The work by Trambauer et al. if focused on the possibility of reliably simulating the flow field in the Holocene peat layer that outcrops in a large portion of The Netherlands.

Interactive comment on Hydrol. Earth Syst. Sci. Discuss., 8, 2065, 2011.

Right bottom part of new Figure 1

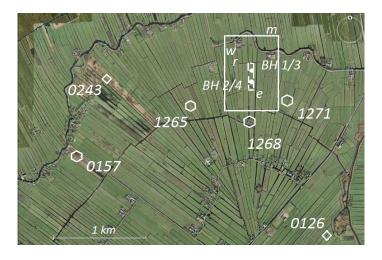
The major problems concerning the work described in the ms are related to the modeling effort. In fact, if the research focus is on the flow field in the upper 6-m thick peat layer, why the model domain is extended down to 300 m depth (p. 2075)?

Indeed we have also had the discussion whether to restrict the model to the CCL of 6 m thick or extend it to the bottom of the groundwater system. The reasons to select the deeper model: 1) especially for the steady state model, pressure heads in the first sandy aquifer to define the model's **bottom boundary** heads were not available at the experimental field. The closest wells with such data are more than a kilometer away from the site (see new figure 1). Estimation of the heads at the field (Kriging) would have led to errors which would have made model calibration more difficult, and 2) an existing regional model was already available to provide hydro-geological input data (top and bottoms of layers/conductivities) for the deeper layers. A motivation for the boundary selection will be added in the article.
